ADDENDUM NUMBER 1

WATER WELL 5F & 8C

March 23, 2023

DETAIL 7 - MCC (PLAN VIEW)
SCALE: N.T.S.

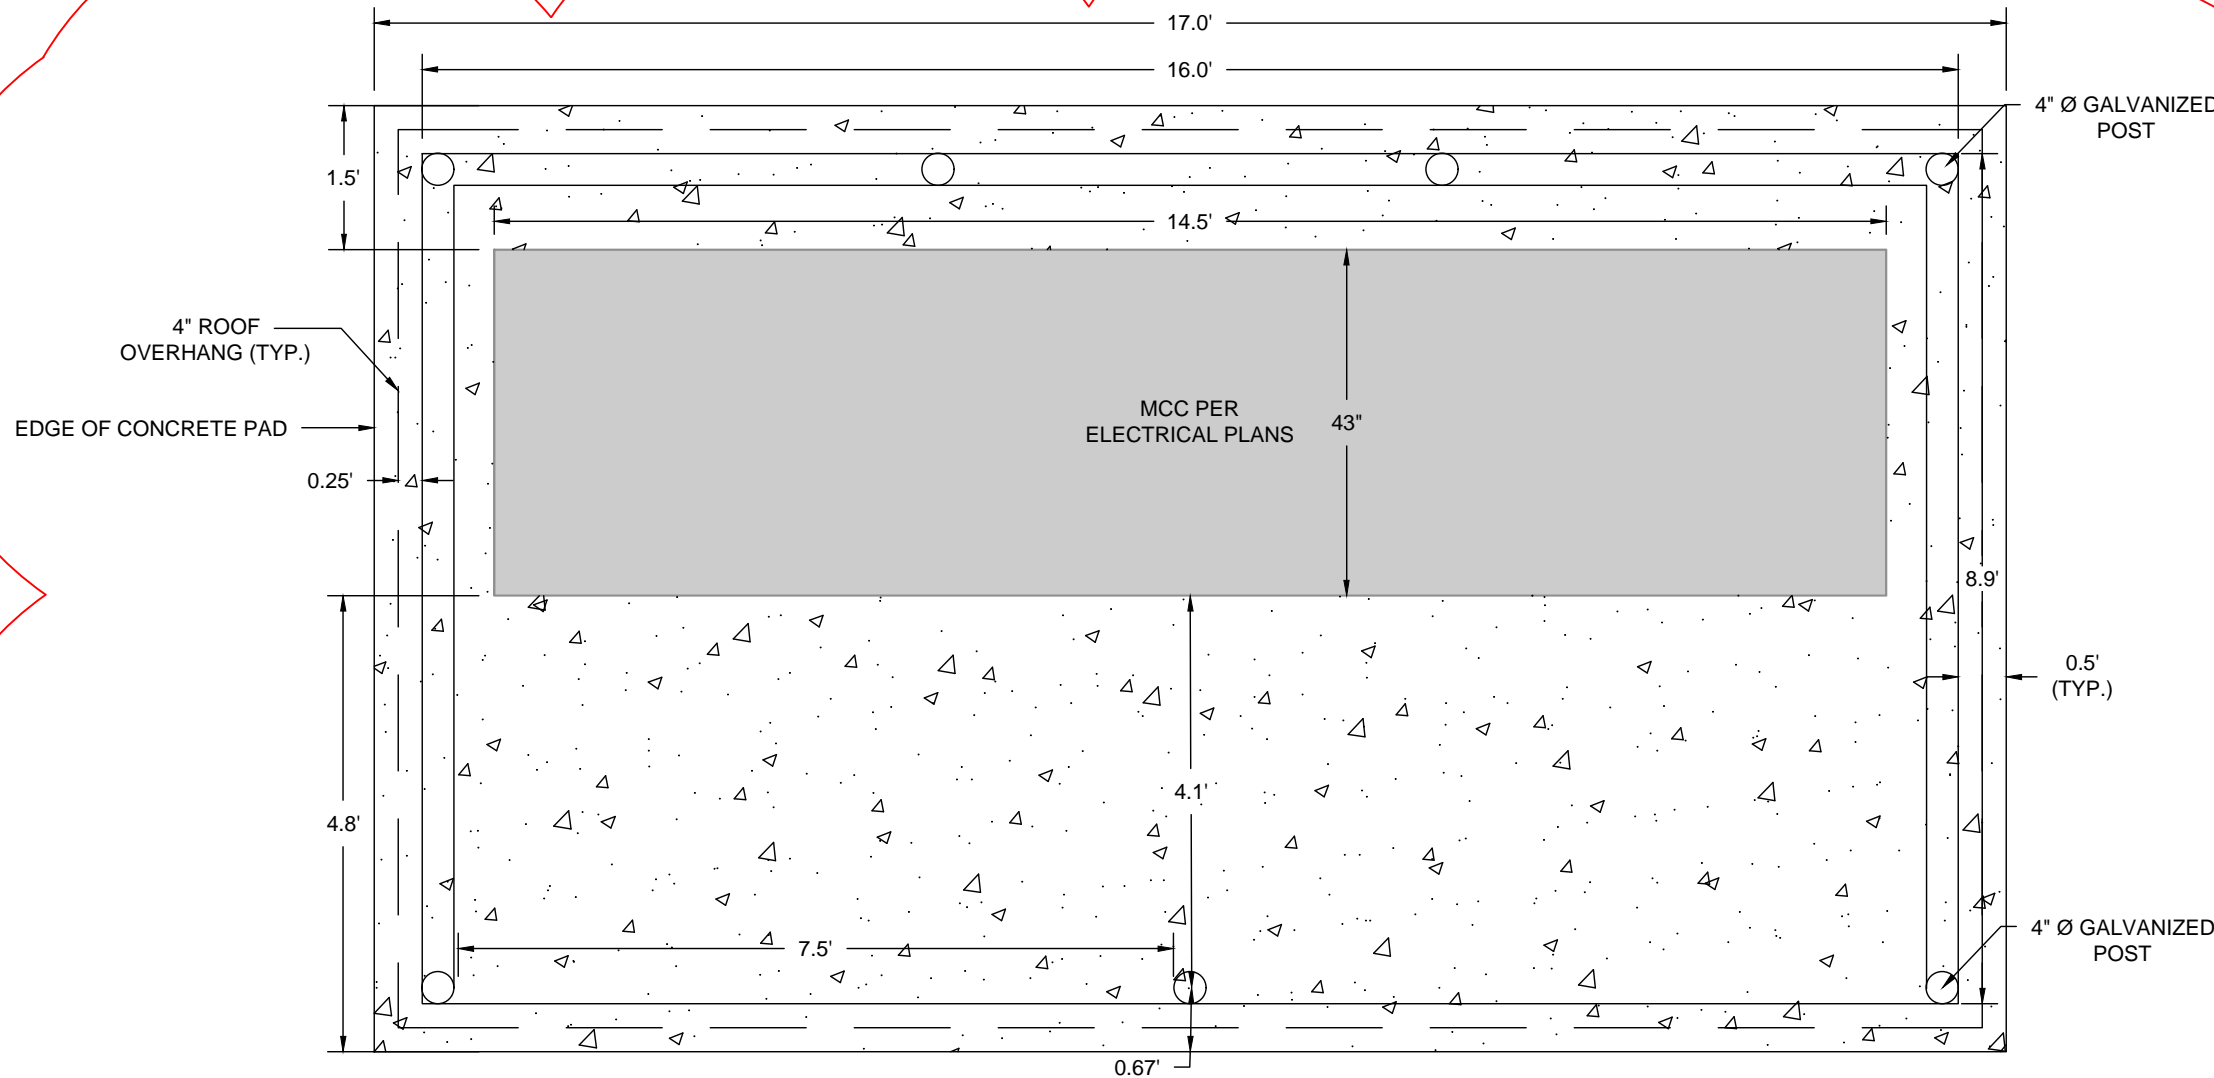
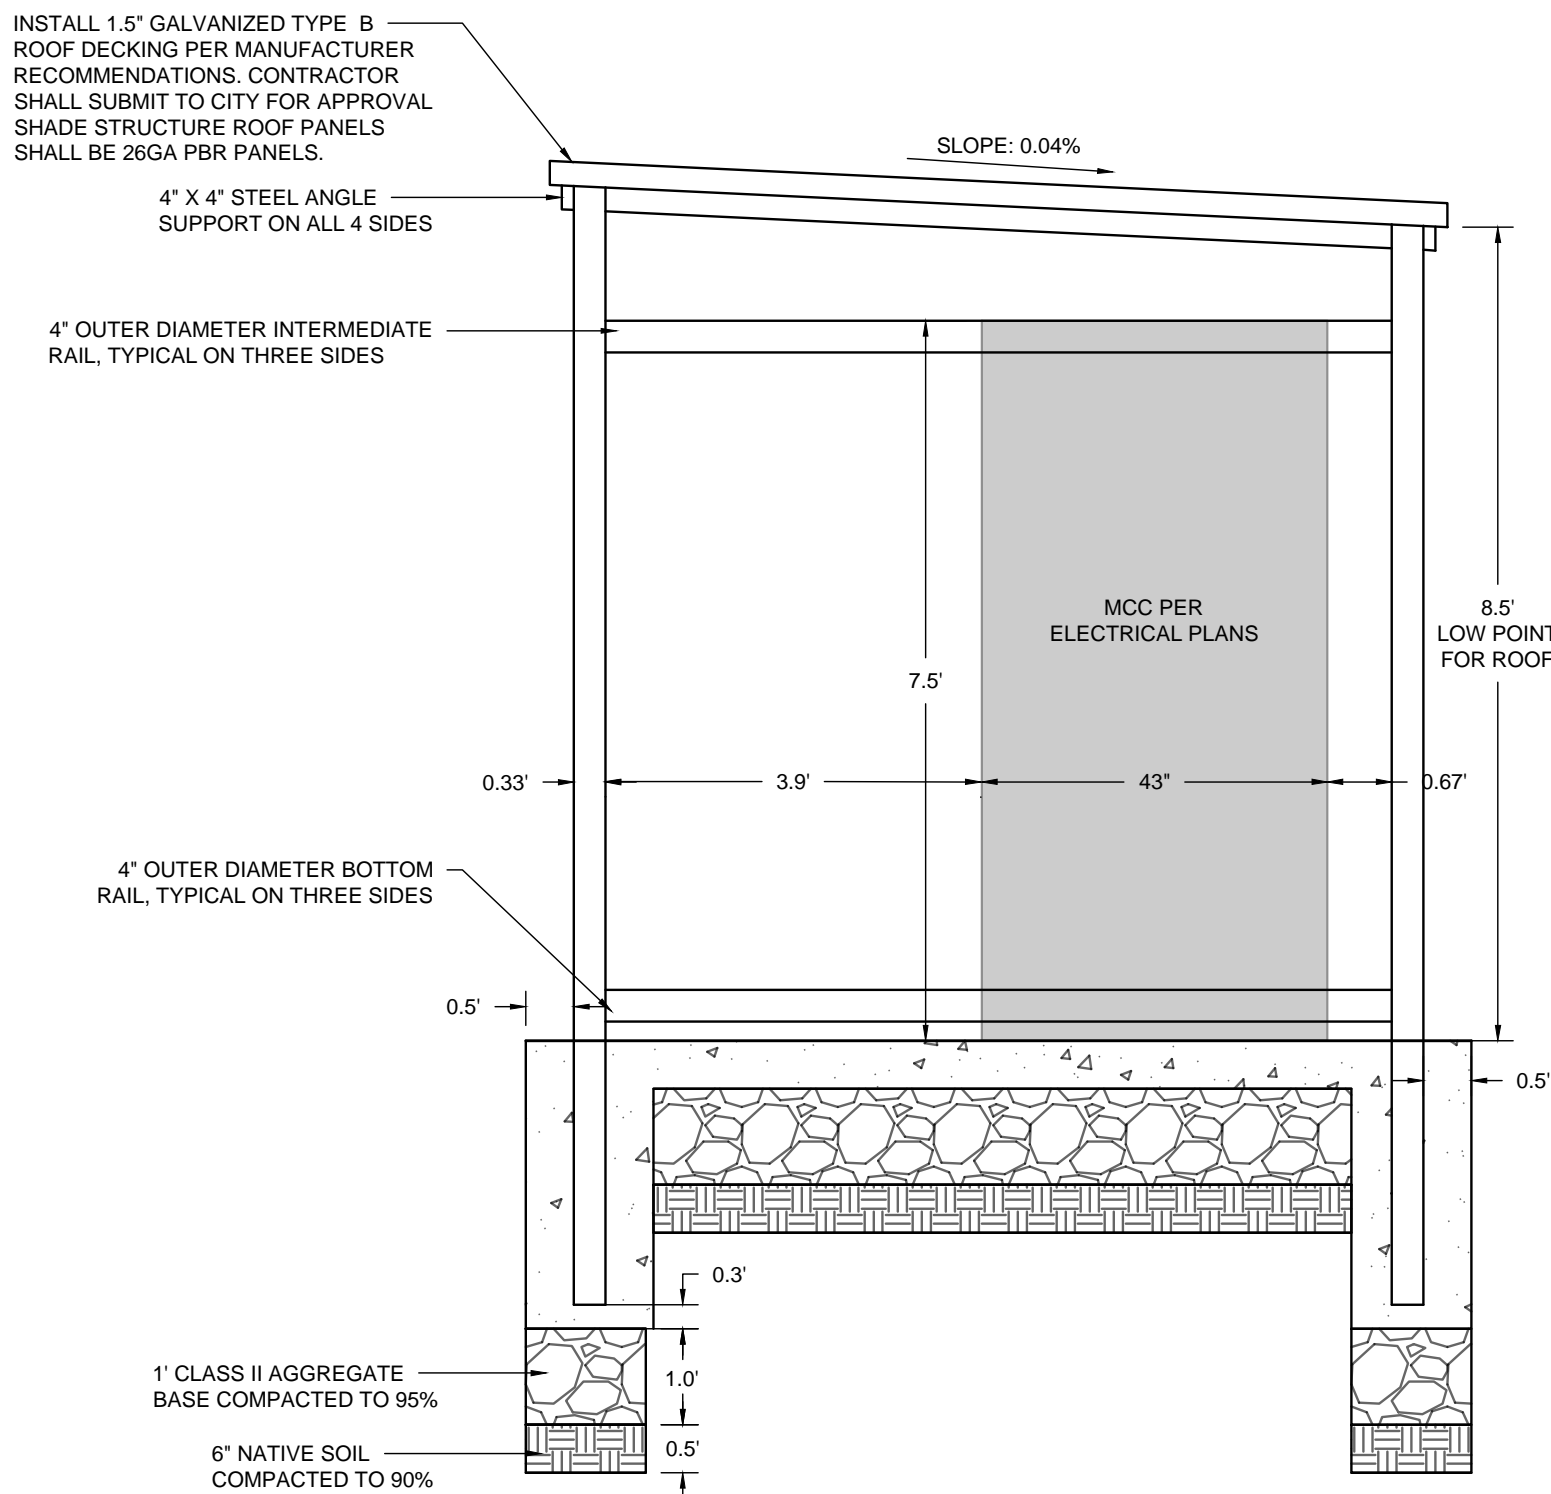
Q20: Will an engineered slab be required under the MCC?

A20: Yes, include a 6" concrete slab with No. 4 rebars at 18" on center both ways over 6" Aggregate Base Class 2, over 12" native soil compacted to 90% relative density.

DETAIL 9 - SAND SEPARATOR
SCALE: N.T.S.

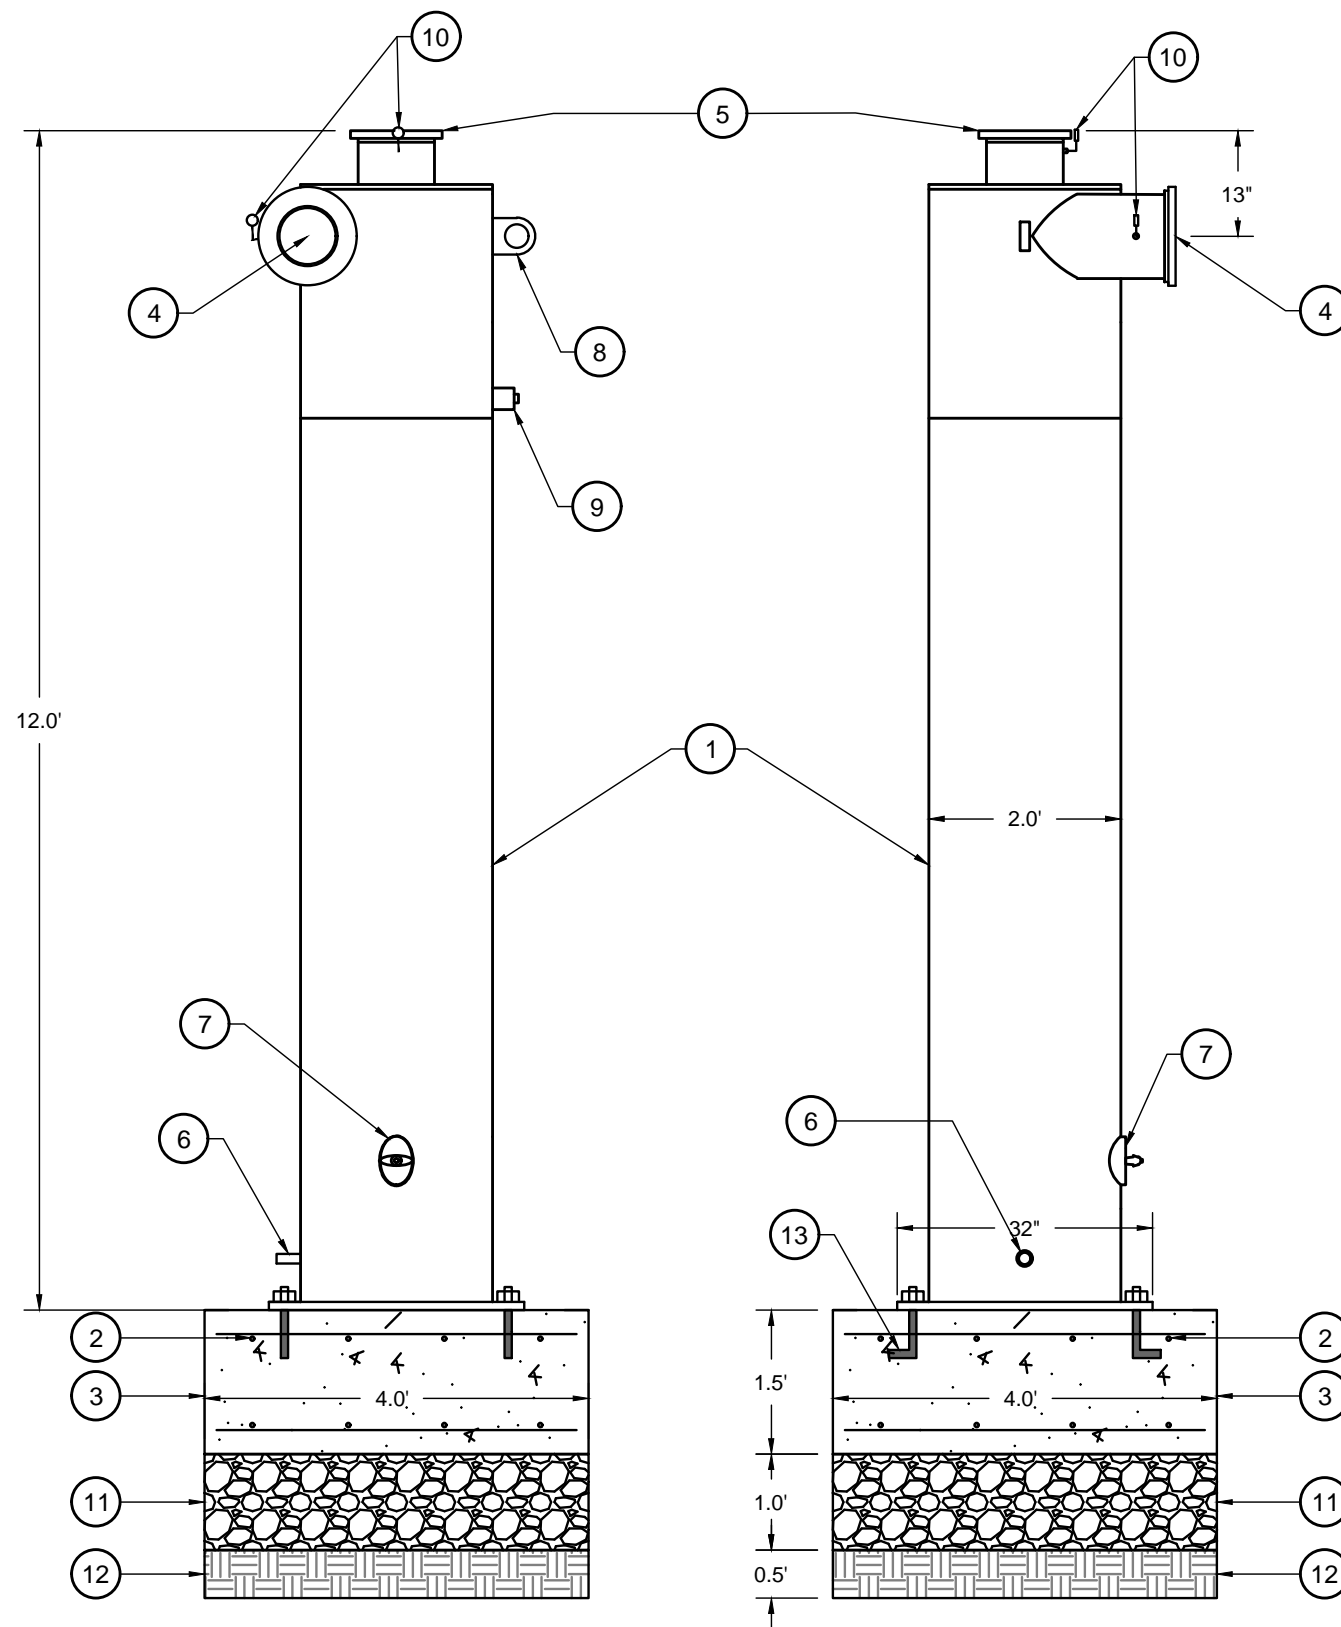
Q2: Please clarify the quantity of separators needed. The plans show a quantity of two (2) PWC-1080-V separators (one per site, 5F & 8C) is this correct?

Q28: Will the sand separator at Well 8B be relocated to Well 8C? or will Well 8C require a new sand separator?

A2: Only one will be required. The existing separator at site "8" will be relocated.

A28: It will be relocated.
